Light Valley Solar

Written Summary of Applicant's Oral Submissions

Issue Specific Hearing 1

Document Reference: EN0110012/APP/LVS/08.08

Plate B-1 Access routes to Solar Development Site 4 as shown in the Transport Assessment

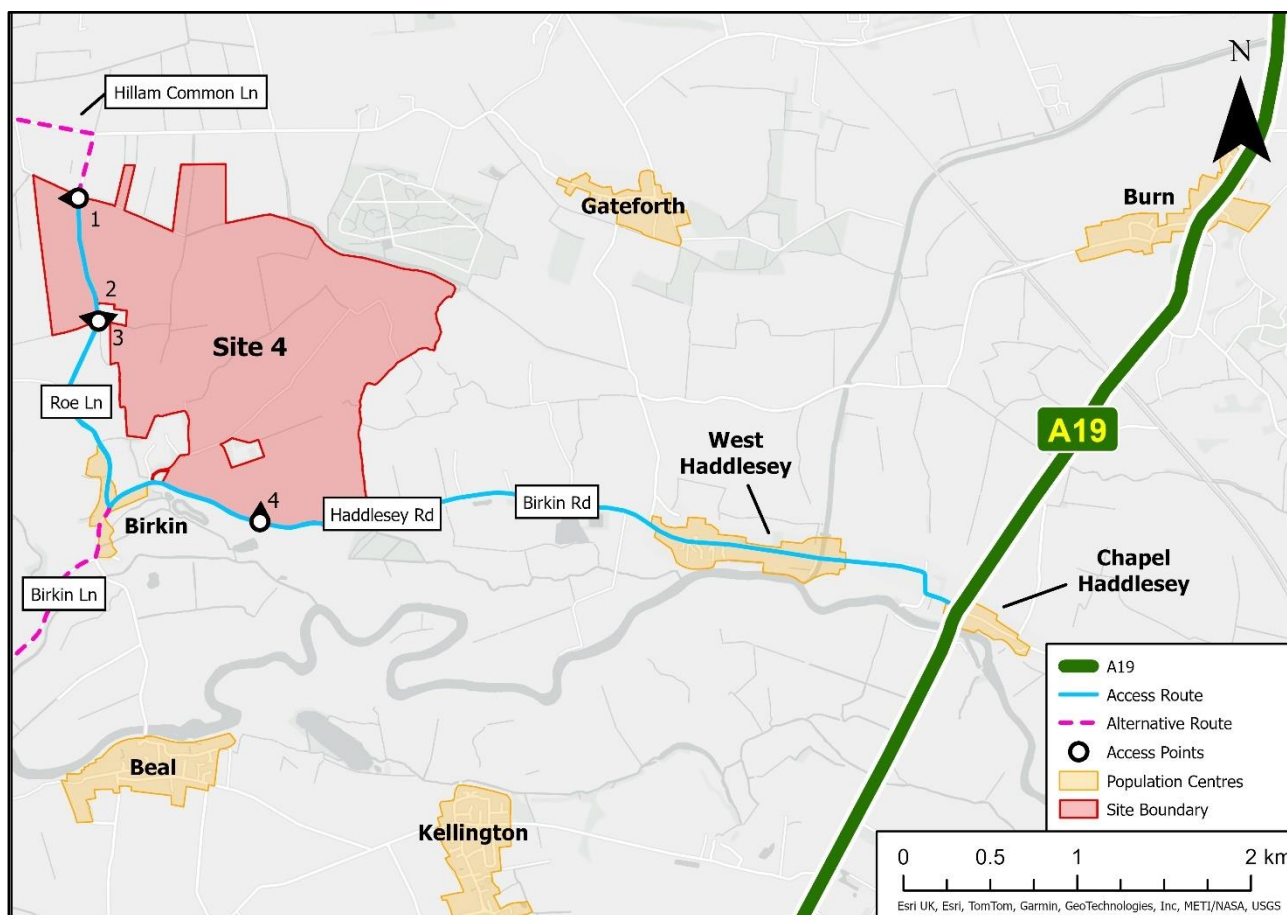
- B.1.1. The Examining Authority has requested that the Applicant make clear the options that have been considered for access route to Solar Development Site 4, and why the route from the A19 via West Haddlesey was selected.
- B.1.2. The purpose of this note is to outline the route selection process for construction traffic accessing Solar Development Site 4. Plate B-1 below shows the selected route via West Haddlesey that was assessed in **Appendix 14.1: Transport Assessment [APP-178]**. Alternative routes considered are detailed later in the note and shown in Plate B-2.

- B.2.4. The prescribed routes are set out and also detailed in the **Outline Construction Traffic Management Plan (oCTMP) [APP-201]**.
- B.2.5. In relation to the approach set out above, the A19 is the nearest strategic road to Solar Development Site 4, and the route via West Haddlesey is the most direct of the approaches from the A19 (shown in Plate 1).

Plate B-2 Routes considered to access Site 4 from the A19

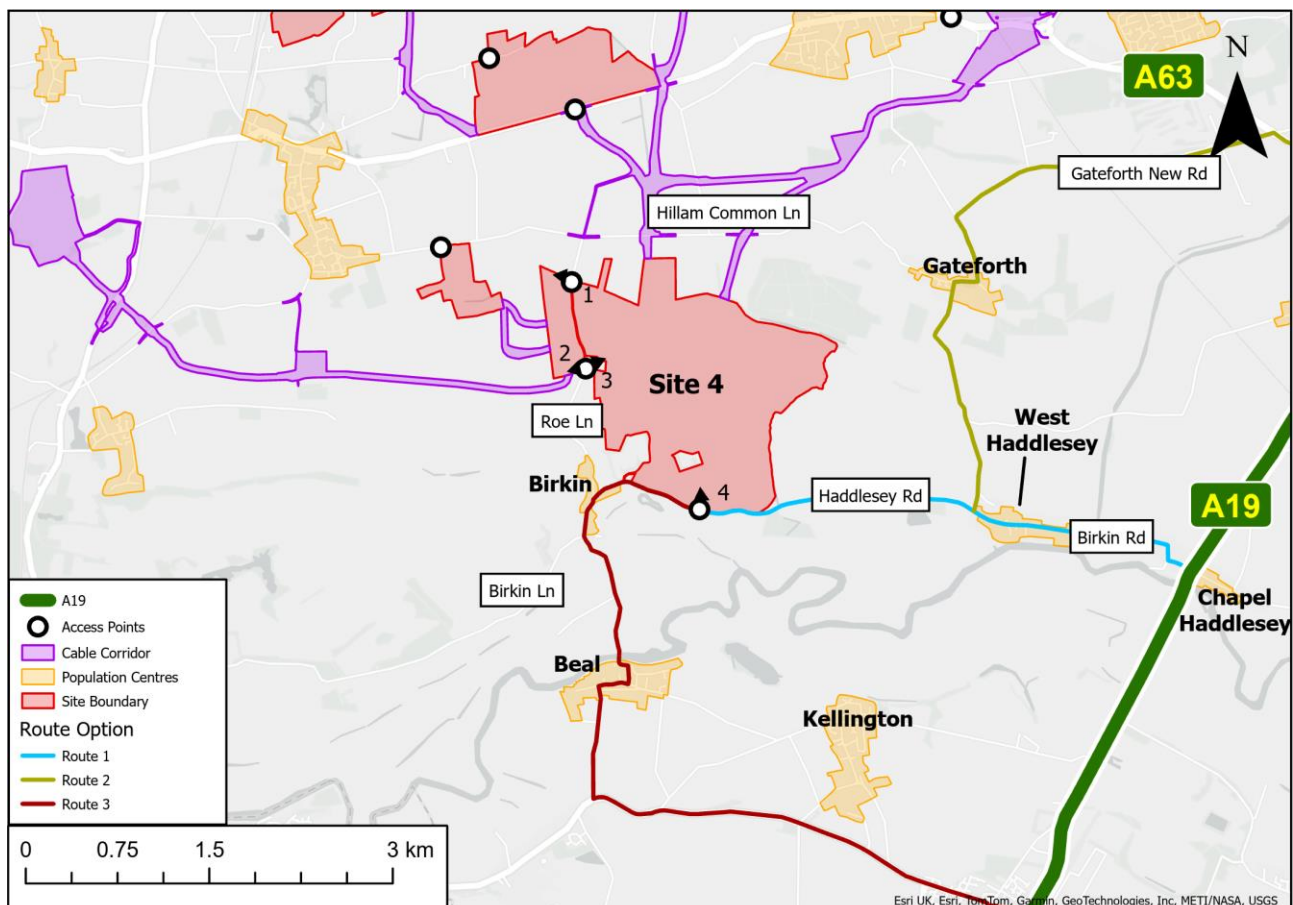
B.4.1. The routes the applicant considered to access Solar Development Site 4 from the A19 are detailed below, and shown in Plate B-2:

- 1) Route 1: via West Haddlesey (the route assessed within the **Transport Assessment [APP-178]**)
- 2) Route 2: via Gateforth
- 3) Route 3: via Beal & Birkin

- B.9.1. Whilst alternative approaches from the A19 via Gateforth and Beal/Birkin were considered as part of the route assessment, they did not provide sufficient transport or environmental benefits to justify selection over the proposed route. To allow a robust assessment of potential transport impacts, a route from the A19 corridor needed to be considered and assessed.
- B.9.2. All A19 approaches require construction traffic to pass through settlements and would therefore generate comparable local effects. Consequently, the route via West Haddlesey was identified as the preferred option as impacts can be managed, noting that the assessment is based on a worst case assumption that
